AL80B (AL800, AL800H) AL572B Mods and Changes

W8JI rev1e Mar18, 2024

Figure 2 older unit EBS Zener mod

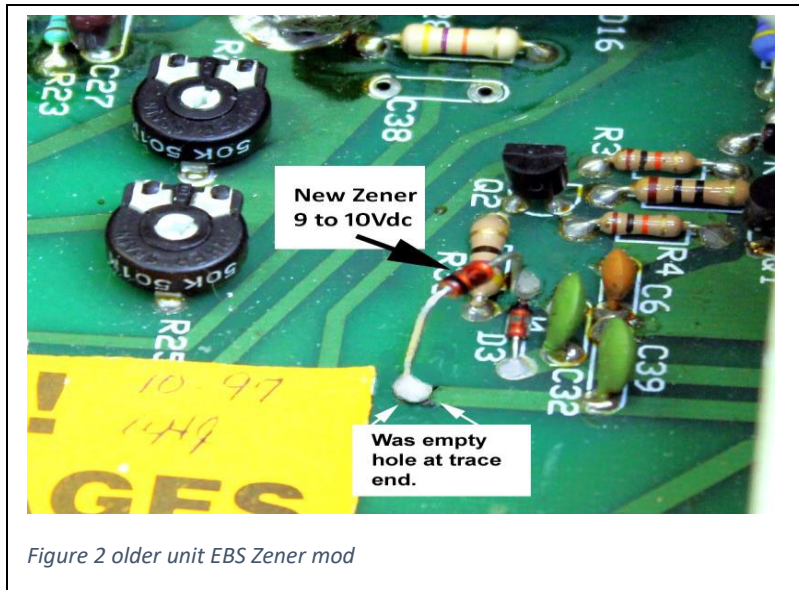
The AL80B only needs one EBS system update. Sometimes audio momentarily clips when the amplifier auto-bias is coming out of the cut-off state. Adding the 1N4739A 9.1V 1-watt Zener supplied in the AL8X kit corrects this issue.

In older open-frame relay units the kit Zener installs as shown with the black-banded diode end toward the empty hole at the end of the trace from the large black transistor on the center panel. The other end of the diode sweat solders to the junction of R30, D3 band end, and C32 far end. R30, D3, and C32 are a common connection point for the unbanded diode lead.

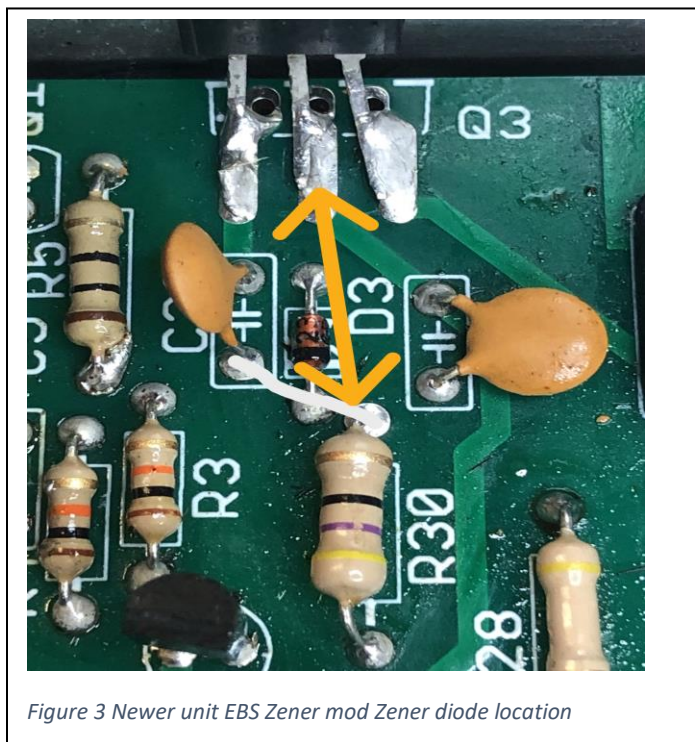
Newer units lack the empty hole in this trace. Later circuit boards with cube (enclosed) relays need the bias Zener installed differently. This is the same electrical circuit position, just a physical location change. In newer units, the Zener fits where this orange arrow shows. Figure 3 Newer unit EBS Zener mod

Zener diode prep for newer models (lacking board hole)

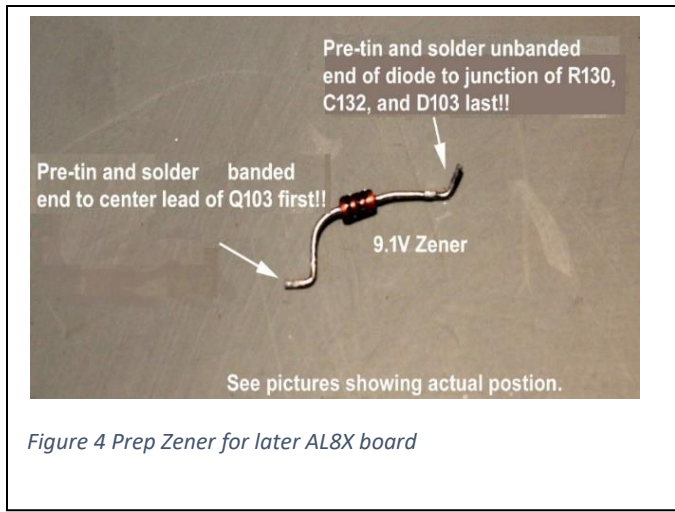
With newer units, pre-form the $\sim 9\text{V}$ Zener as shown (note: the exact voltage is not critical). Cut the leads each about $\frac{3}{4}$ inch or so long before bending. Just be sure the diode will fit the final position before snipping! Figure 3 Newer unit EBS Zener mod

Figure 5 new diode from center of transistor Q3 to R30 or D3 (banded) end.

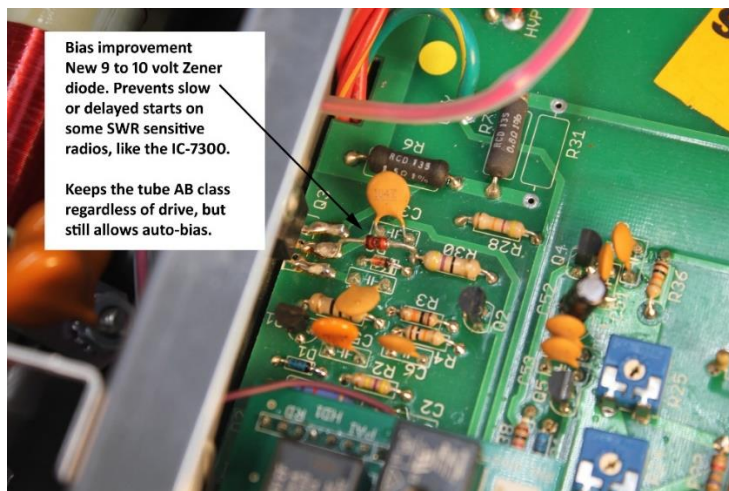
Later AL8X frame amplifiers require the banded Zener lead sweat solder directly to Q3 (big black power transistor) center lead. The unbanded wire end ties to either R30 or D3 banded end. R30, C32, and D3 are common. A short or accidental solder bridge between them at the common point does not matter.

Figure 8

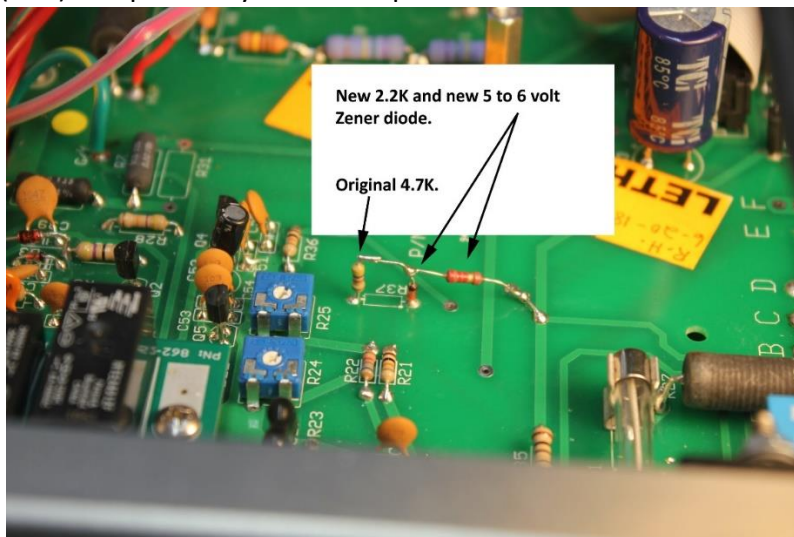
A reasonably simple circuit modification corrects best-case timing from 25-35 mS to about 7-8 mS in the worst case. This mod uses a 2.2K resistor, a 1N752A 5.6V Zener, and one .33uF to .47uF timing capacitor. One diode (not on the MFJ schematic) is removed, and one electrolytic (C52) is replaced by smaller capacitor.

The original 4.7k resistor R37 is lifted on the end shown. A Zener and 2.2K pull-up resistor are added. This modification creates a much lower source impedance via the new 2.2K resistor. The ~5-volt Zener greatly increases the threshold. The source current goes from a fraction of a milliampere to about 4 mA with a threshold voltage of about 5-6 volts instead of less than .7

Figure 9 Relay area schematic

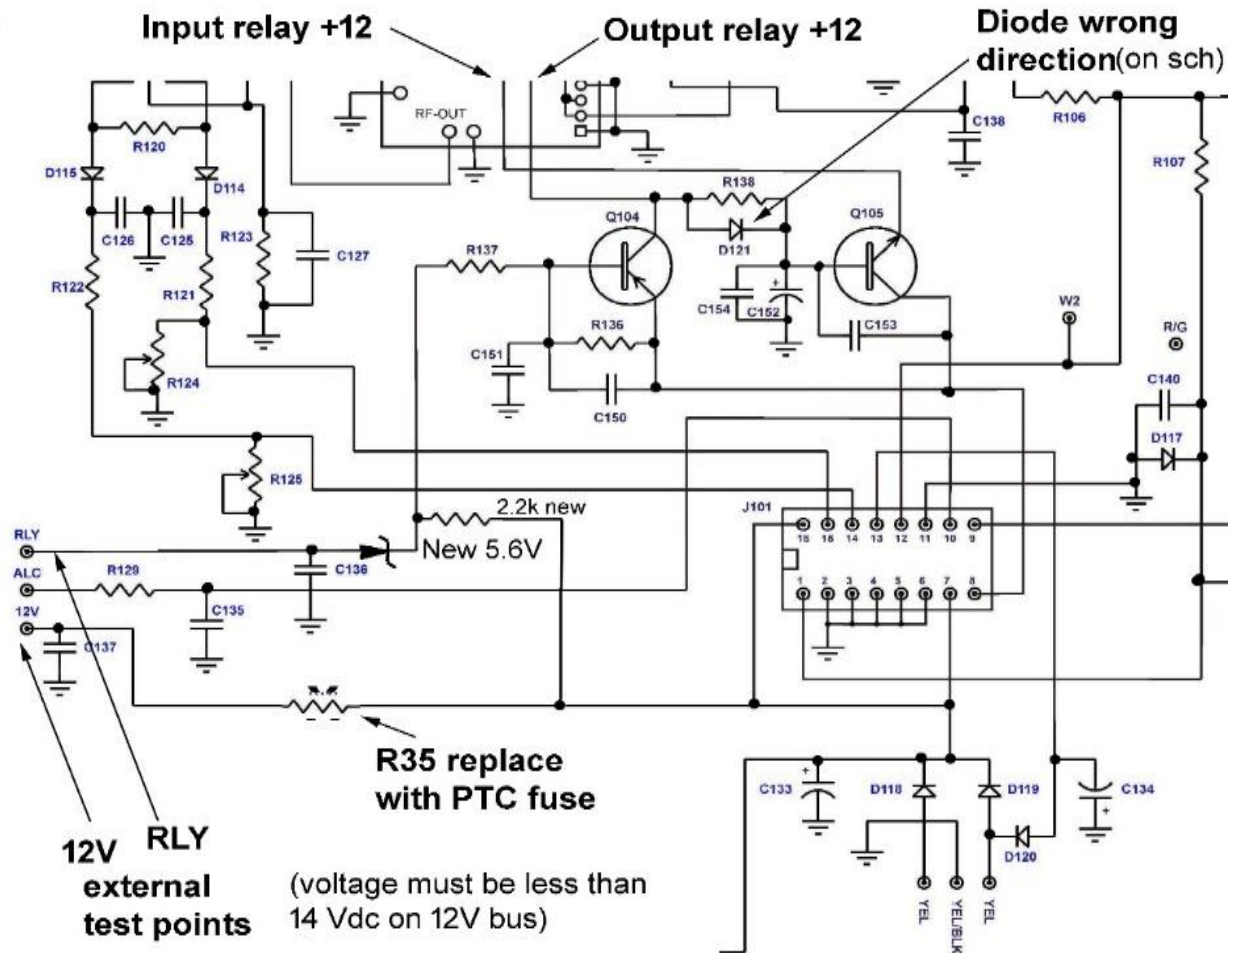
volts. This modified system is well within the range of virtually any radio. It makes the keying line less sensitive to capacitance, RF, or leakage resistances. (Diode D121 is shown backward on the schematic.)

Figure 10 remove C52 (C152)

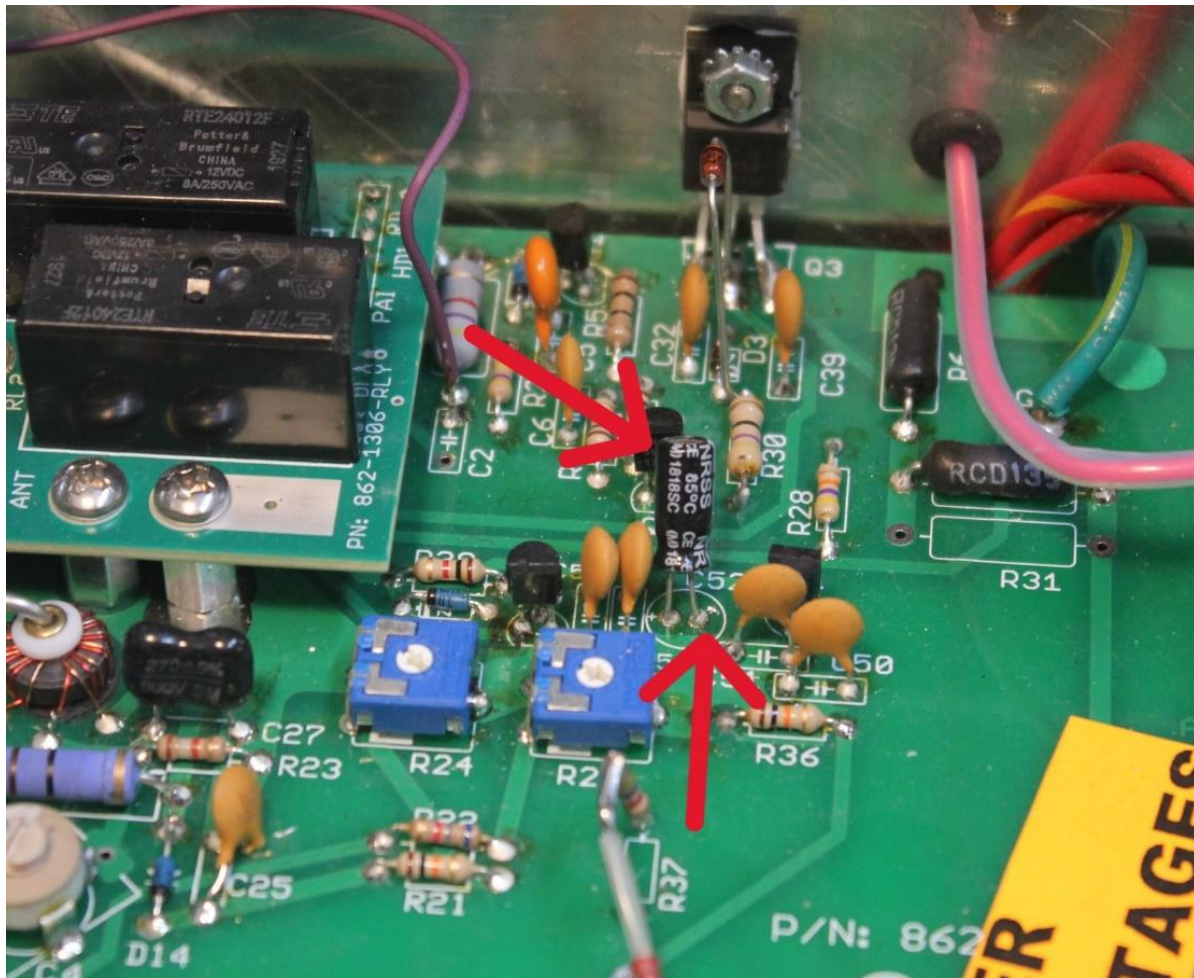
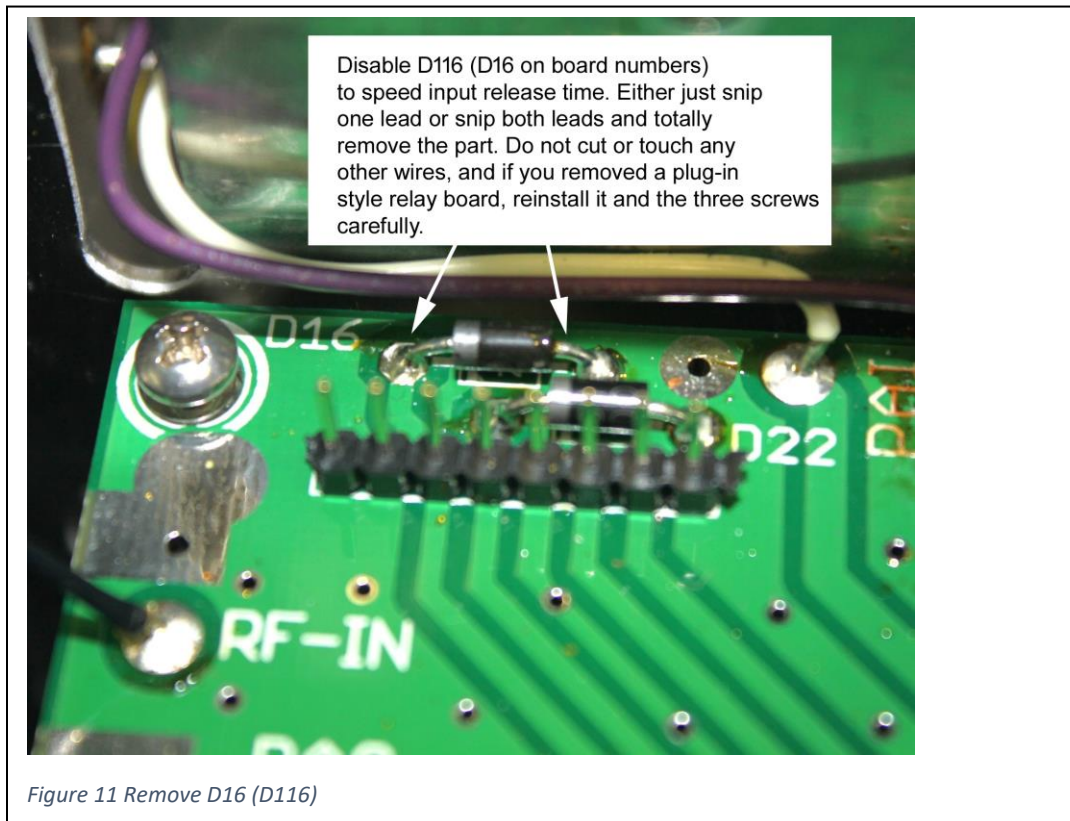
C152 (labeled as C52 on the board), a small electrolytic, must be removed and replaced with a .33 to .47uF capacitor.

C152 is replaced with the kit's small .33 to .47 uF capacitor. The kit capacitor is not sensitive to direction.

Figure 12 Pink Bleeders and fault resistors

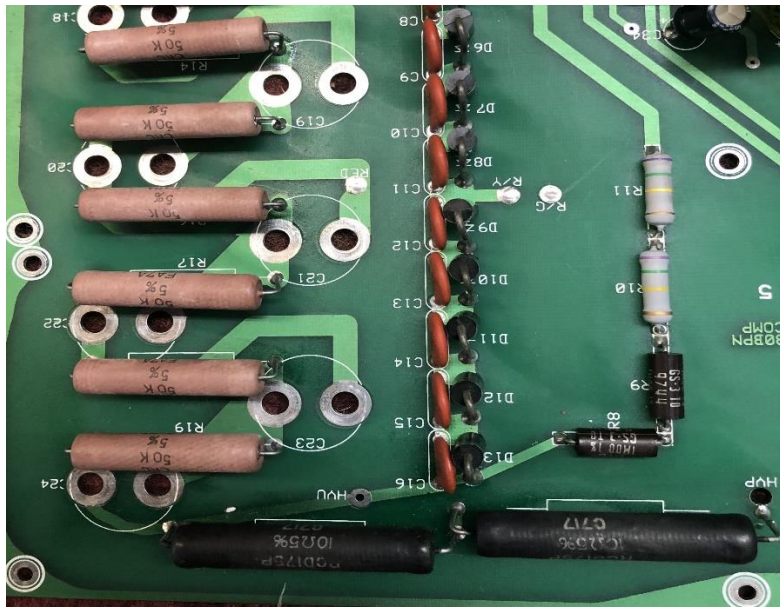
The high-voltage power supply in the AL8X series (AL572, AL80B, AL800) is pretty reliable. The only common problem spots in the HV supply area are units with pink or light tan colored 50K 7-watt bleeder resistors. We have a policy of changing the pink or tan resistors shown in Figure 11. Any good quality 7-watt 50k-75K ohm resistor can be used to replace the troublesome resistors.

The two black 10-ohm fault limiting resistors at the bottom of Figure 12 are an excellent idea. If you need the replacement bleeders or the 10-ohm parts let us know.

Figure 13 New Zener buck diode in severe 12V supply cases installed as shown.

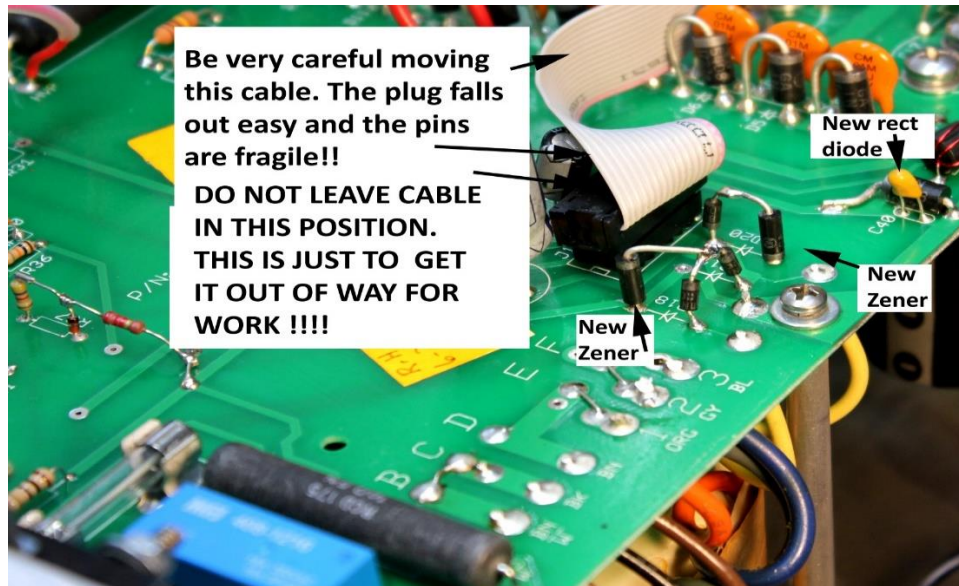
Voltage can be reduced by patching in bucking Zener diodes at the low-voltage rectifiers. Our kit has two 1N5335B 3.9Vdc Zener diodes. If the voltage is over 17 Vdc, install a supplied 3.9V 1N5335B Zener diode in the negative and positive system as shown. Be sure the 12V line, as

tested at the rear jack, does not go below 13.5 Vdc. If the voltage is 14-16Vdc, just install one Zener in the negative single rectifier. You can leave the dual diodes on the positive side alone.

The op-amp that goes over-voltage runs on a differential between the negative and positive supplies and is rated at 32 Vdc differential. At 16 Vdc on each supply, the op-amp is right at 32 Vdc. Reducing the negative supply to -10 to -12 volts will be enough to save that op-amp.

Figure 14

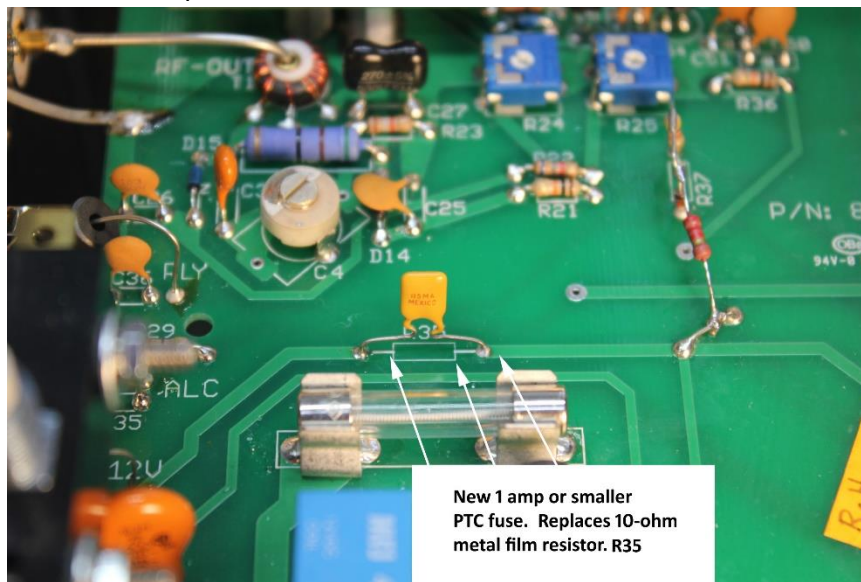
R135 (R35 on board) should be a 10-ohm ¼-watt film-type resistor (ideally metal) used as a fuse. The 12V jack is low current, provided for external “power on” or external accessory lights or metering in antenna tuners. To prevent damage if the 12V jack is overloaded or shorted, R35 was added. R35 limits short current to 1.5 amps until the resistor opens.

R35 can be replaced with a PTC auto-resettable fuse included in this kit.

Figure 15

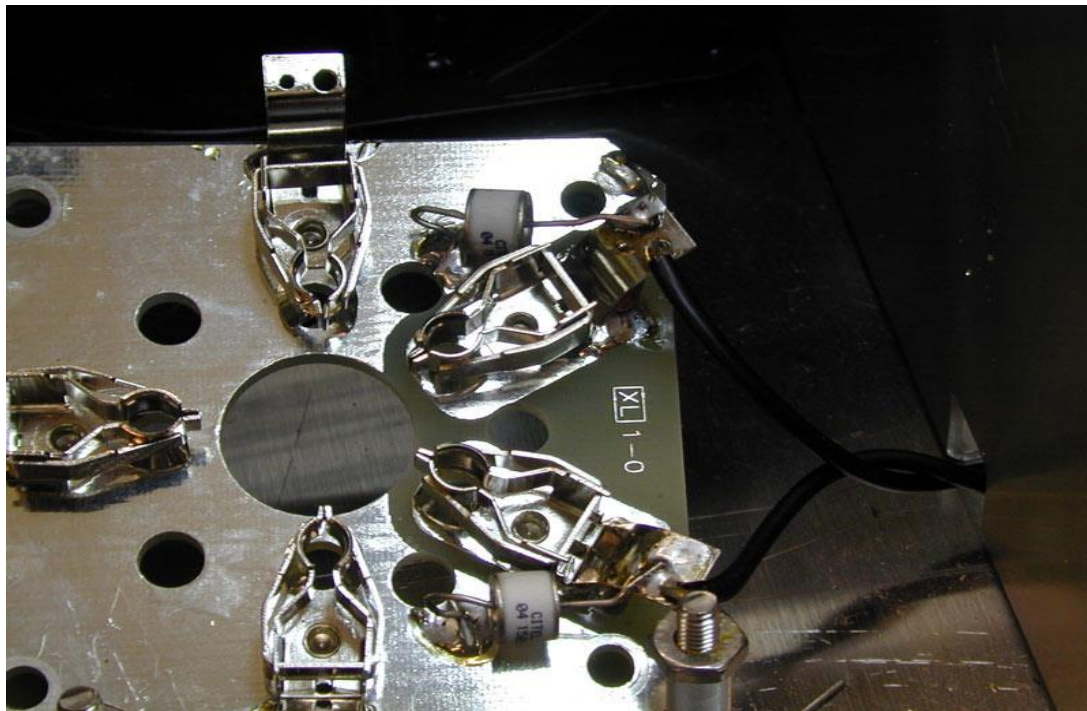
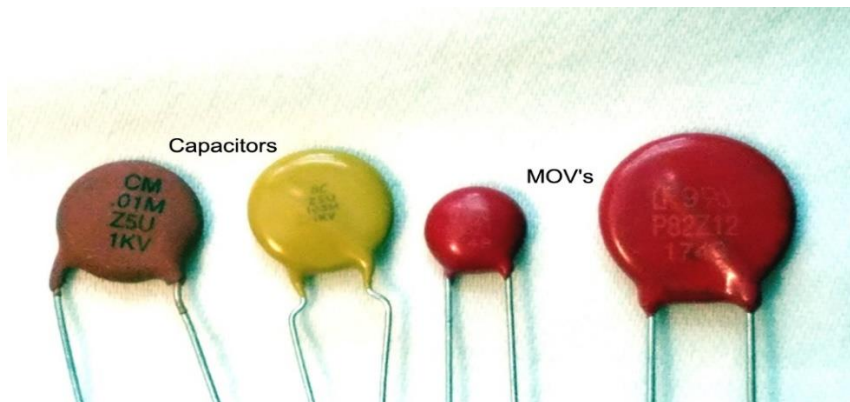
Remove any red color MOVs near the filament choke. Install two supplied GDTs under the socket, unless your unit already has them. The socket is relatively easy to remove if your amplifier does not have GDT's. Be sure you do not create a short adding the GDTs.

Additionally, look for red MOVs (they will not have a capacitance value on them) on the supply side of the filament choke. Remove all MOVs.

Figure 17 Ground 572B control grid pins

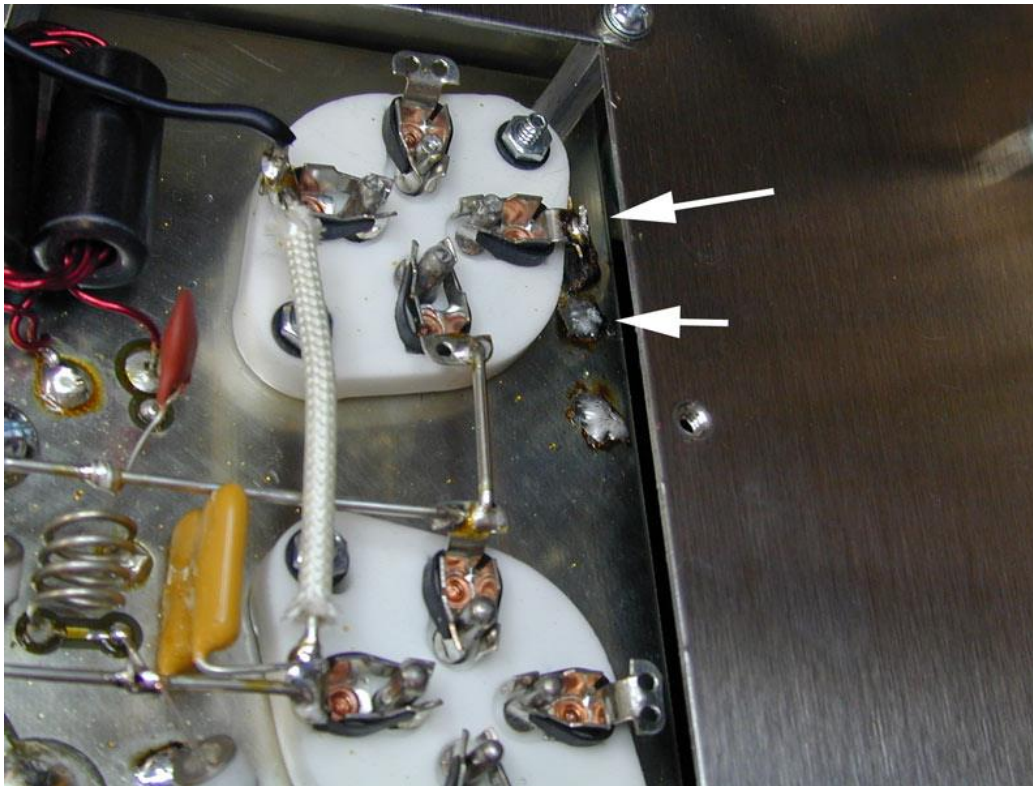
Early AL572 amplifier had control grid floating. We include braiding to ground the grids. Hopefully your amplifier will have a removable chassis bottom plate below the tubes.

Remove that plate and remove the four resistors and the orange .01 uF 1kV disk capacitors that go from the control grid pins to the printed circuit board that is used as a tube chassis. The braid can be soldered directly to that silver board.

Figure 18 GDTs AL 572 amplifier

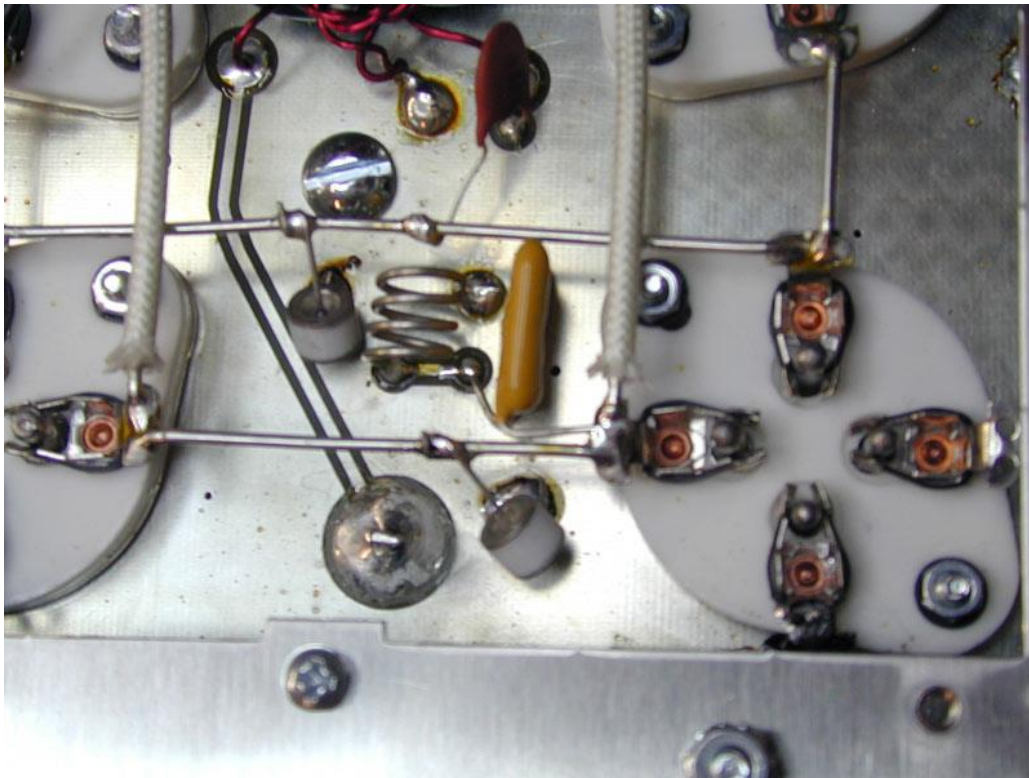
Add GDTs, one from each side of the filament, to the silver board. Be sure to not accidentally cause a short circuit.

Figure 19 Good transformer insulator

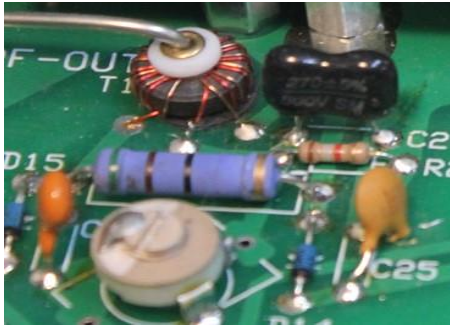
The SWR bridge and directional coupler is another chronic problem. The original layout was supposed to have a grounded eyelet in the coupler transformer. The grounded eyelet allows the use of a Teflon-insulated wire through the eyelet.

A patch for this error was changing the center insulator from plastic to a white Teflon. A good transformer has a pure white Teflon center insulator in the toroid.
